TOGA Central

Response to Submission

TOGA

November 2022

fPPb - Ground floor - revised design

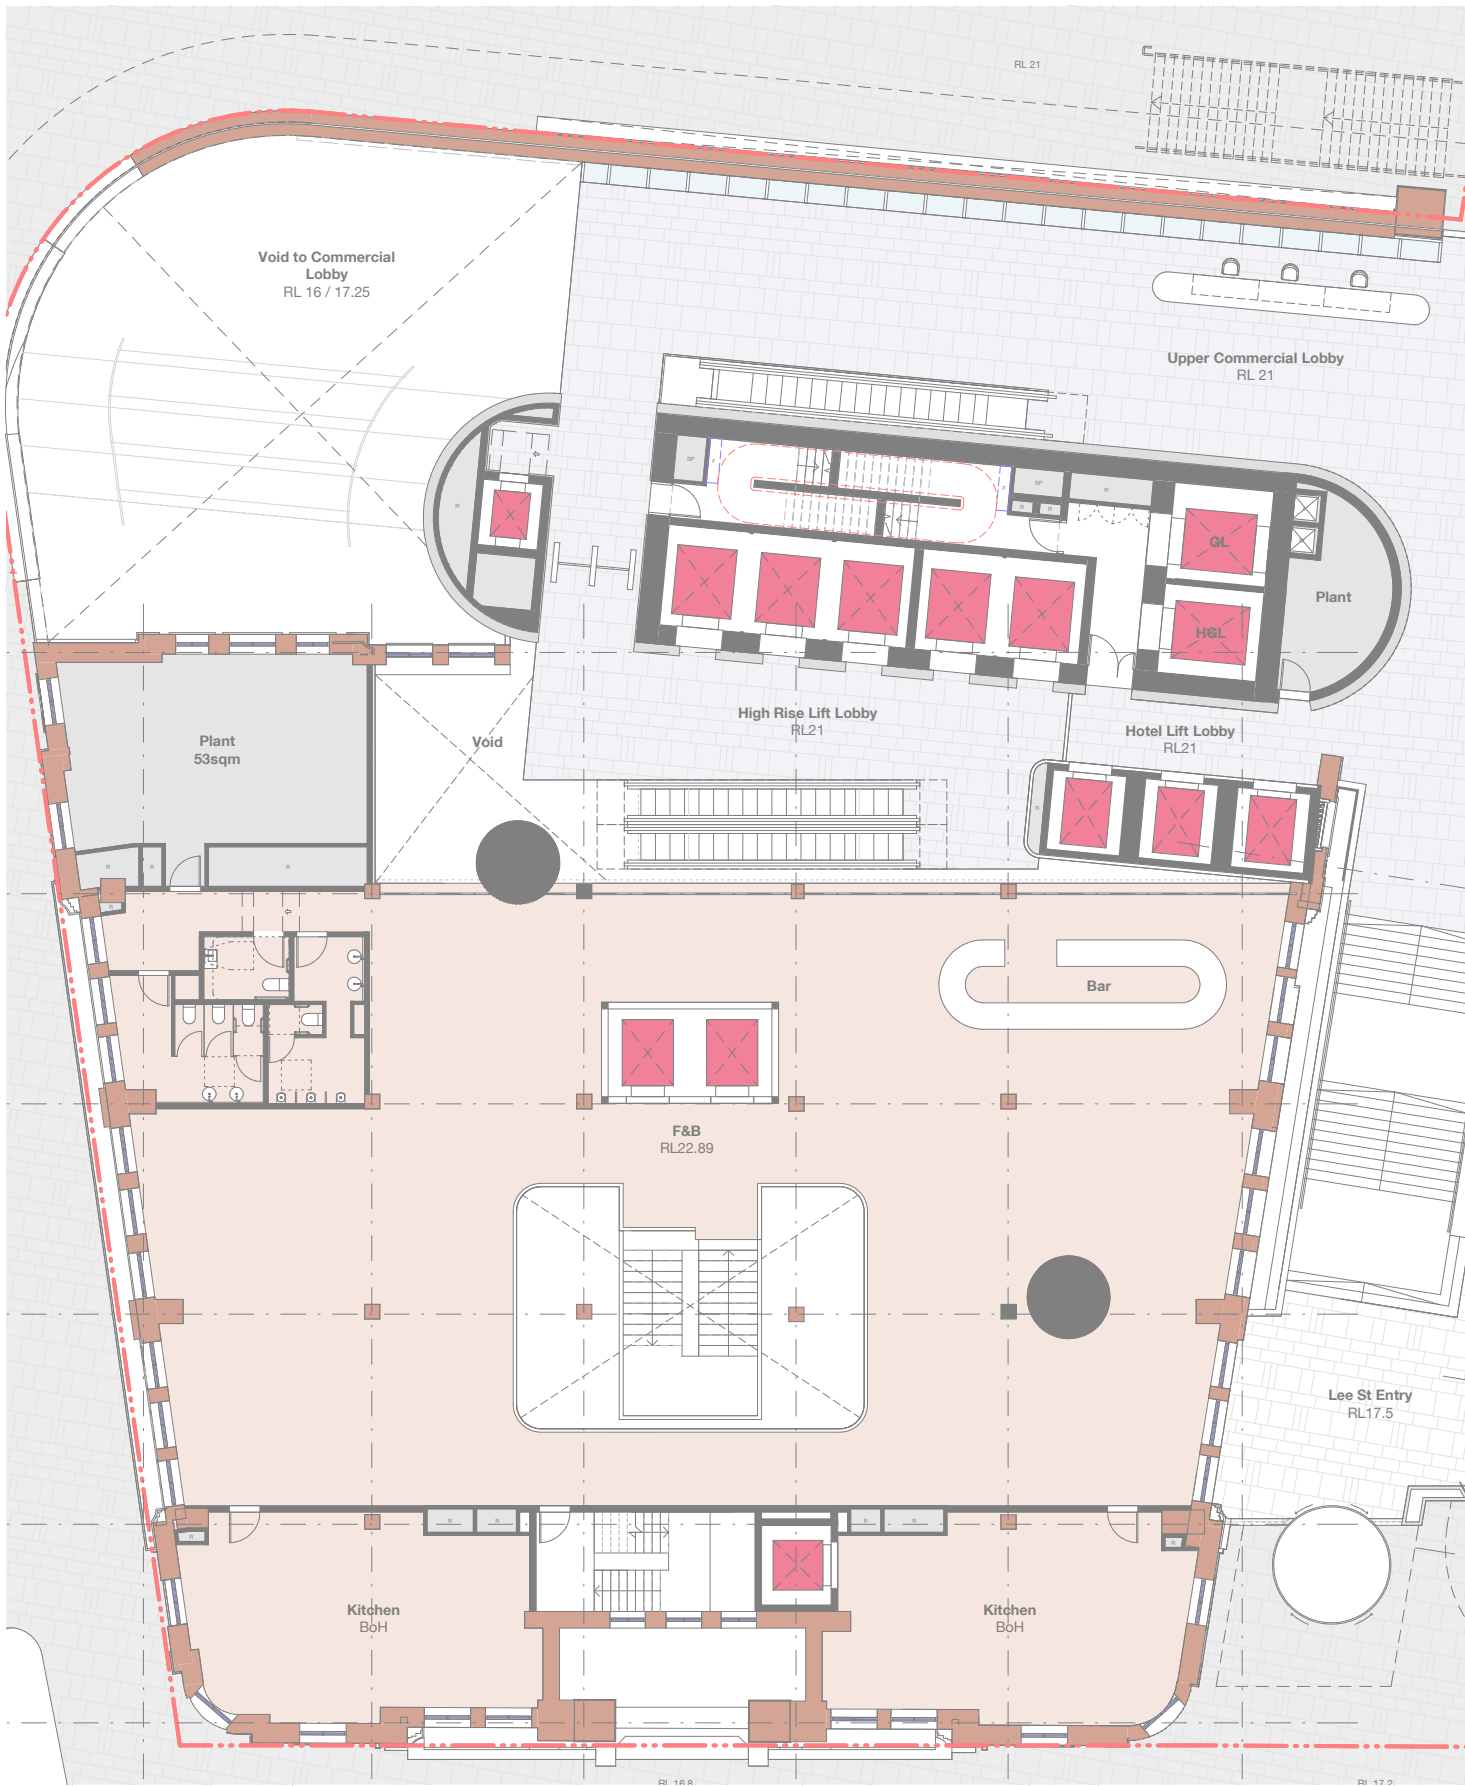
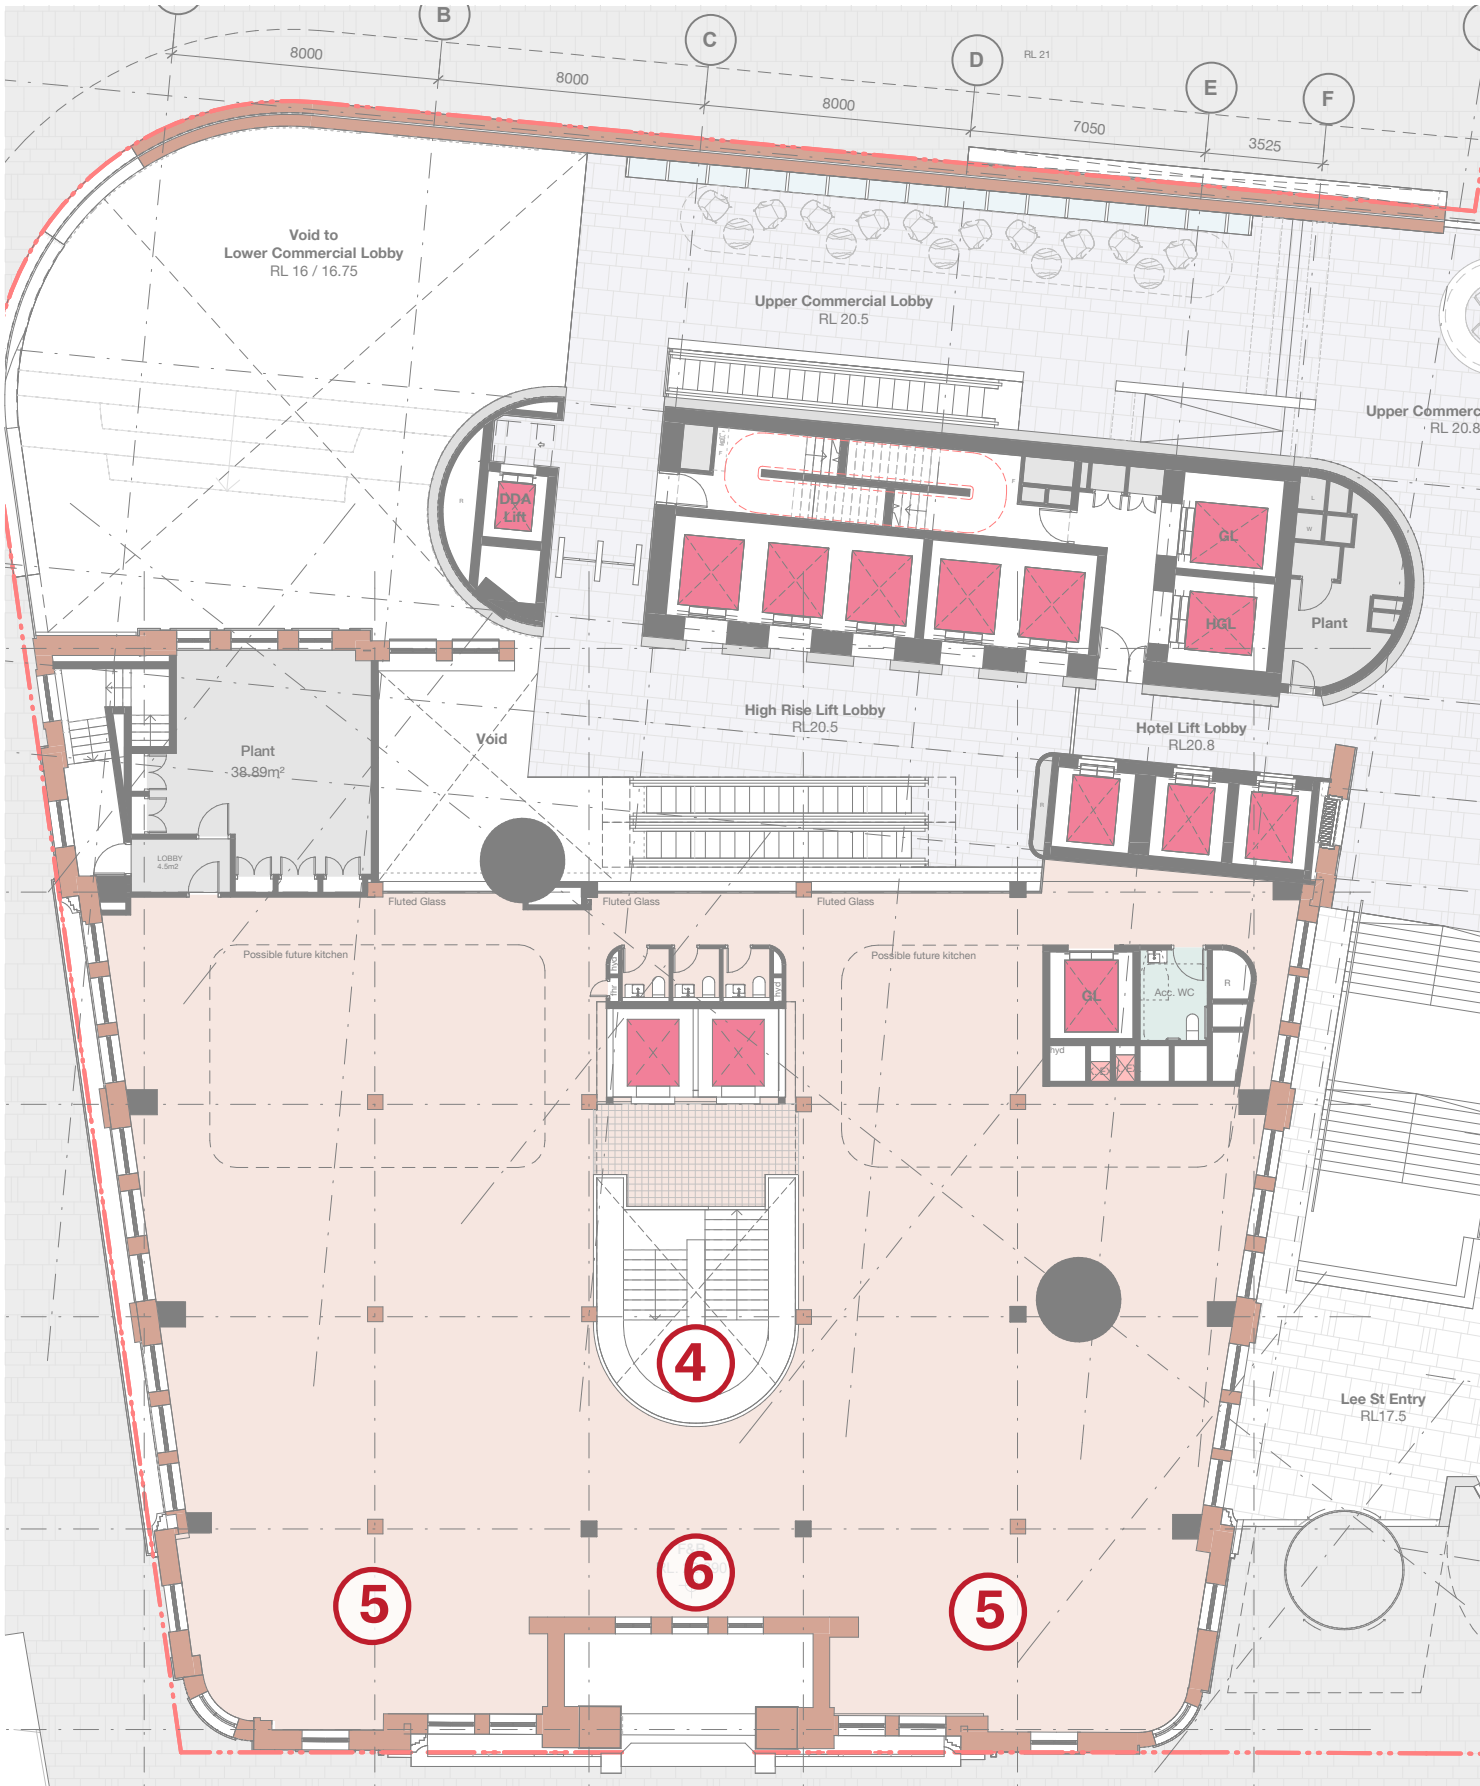
The Department notes the concerns raised by Council about the extent of proposed internal demolition and reconfiguration and the number, size and proportion of new openings within the rear yard retaining wall. In addition, the Heritage Council has stated the internal spatial layout and configuration of the fPPb has heritage significance and should be reinstated where possible. The Department recommends the proposal is further refined/ amended to address the above key comments raised by Council and the Heritage Council to ensure heritage impacts are minimised.

The Design has been further developed in response to these concerns as follows:

- 4** - Atrium shape adjusted in line with upper floors, to reduce impact to existing structure.
- 5** - Indicative kitchen zones moved east to maximise key heritage internal spaces
- 6** - Stair and lift relocated.

fPPb - Ground floor - revised design

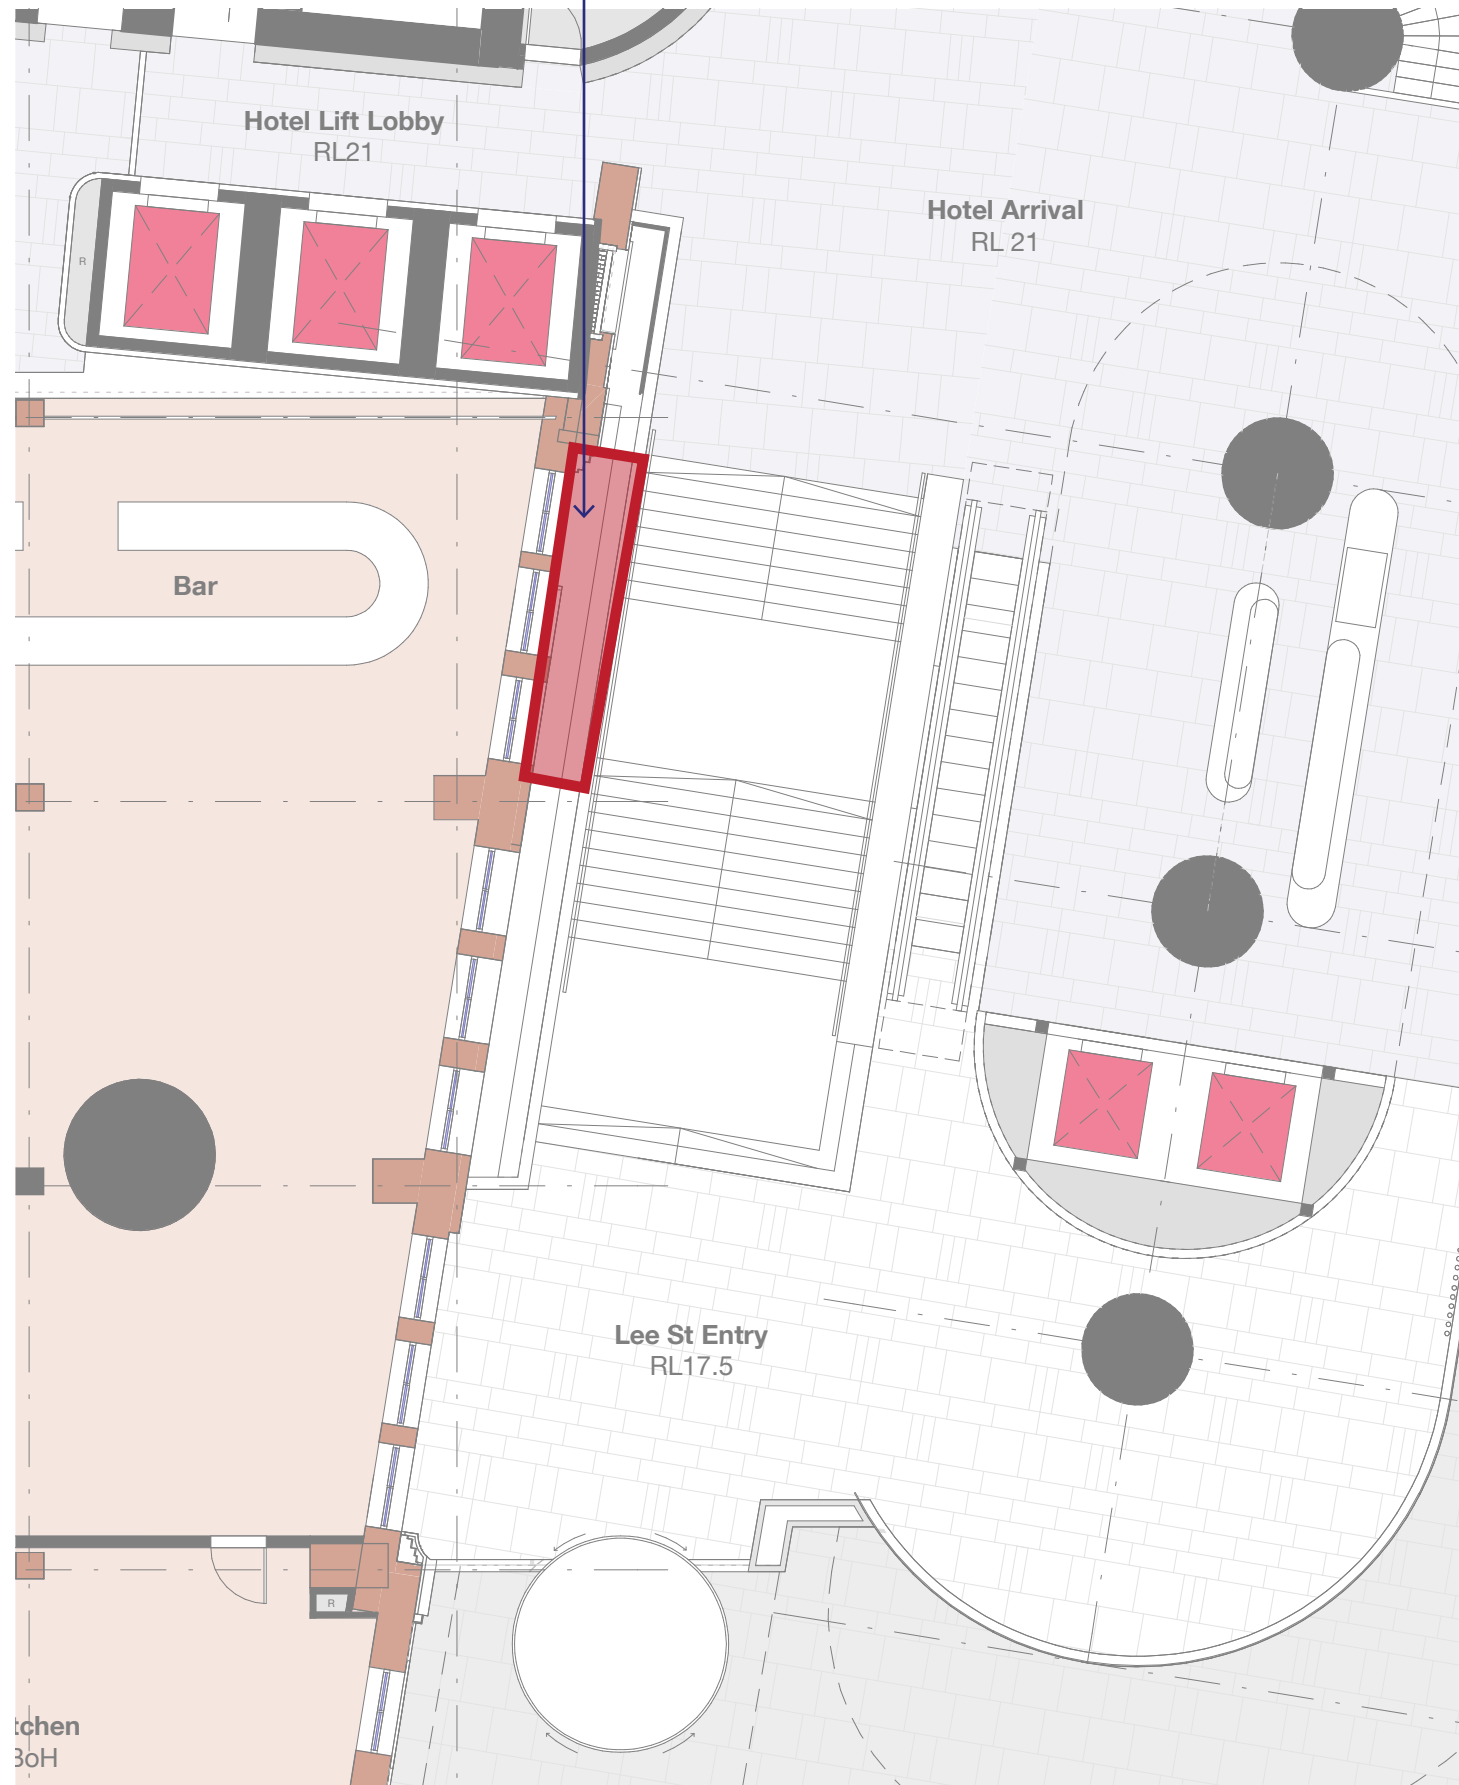
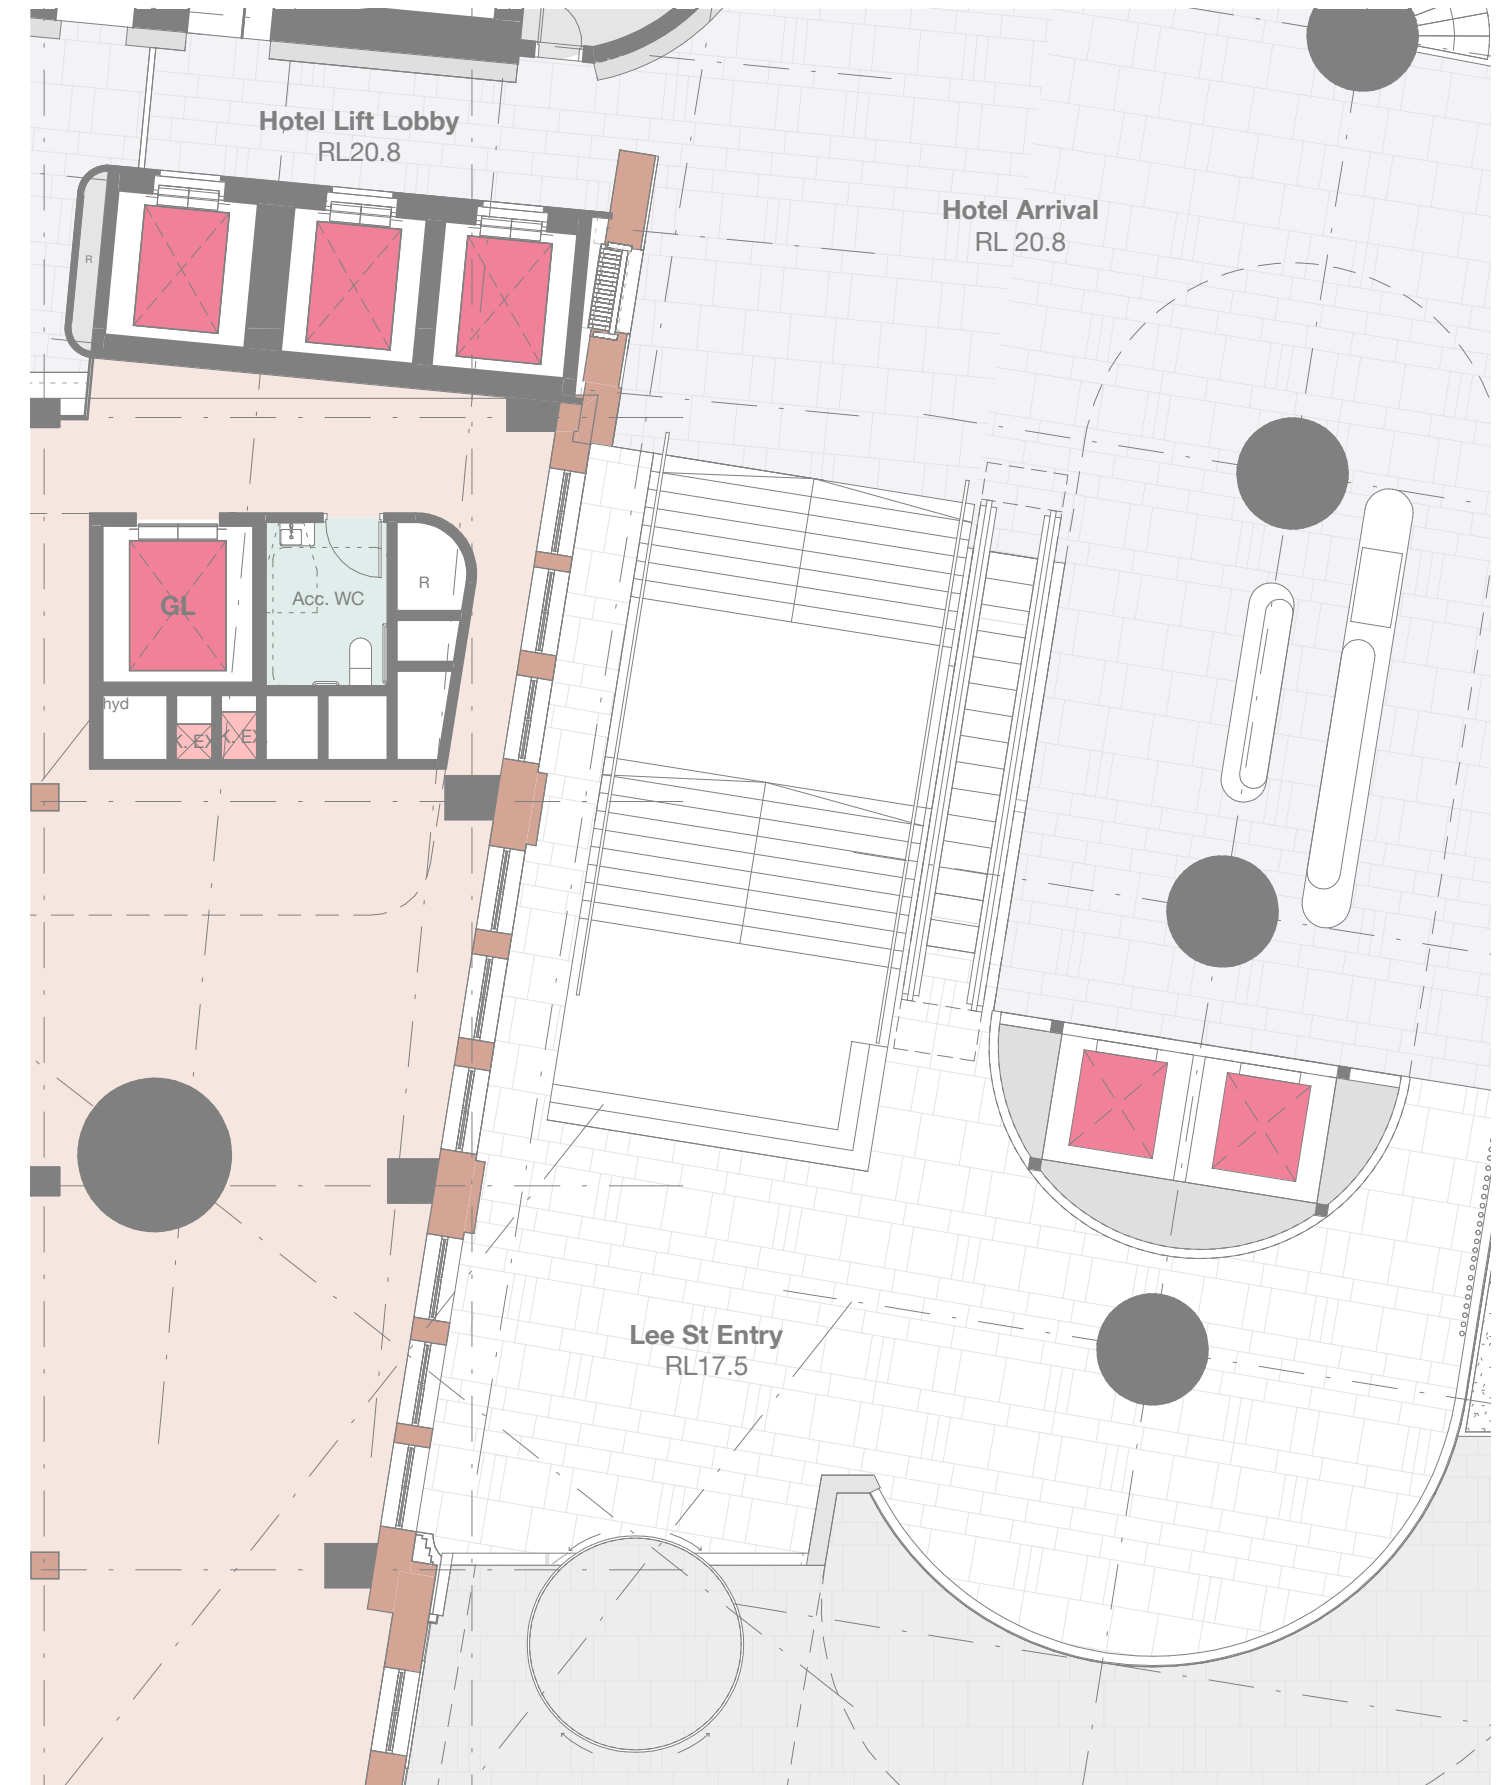
Consider options to relocate/redesign the stair case within the atrium between the fPPb and the southern pill to improve the visibility former bronze frames shopfronts (fPPb southern façade). Options could include relocating the stair case further eastwards, narrowing the width of the stair case or another suitable alternative.

Studies were carried out to test different offsets of the stair from the heritage facade. A deciding factor has been the Lee Street tunnel constraint below. With limited head height, the most easterly facade bay adjacent the stair.

A compromise was found in offsetting the stair by 900mm from the outmost fPPb facade pier and limit head height constraints in the tunnel below. This enables the stair to be fully detached from the facade, the heritage facade to reach the ground at its full length, and avoid significant impact to pedestrian flow in the tunnel below.
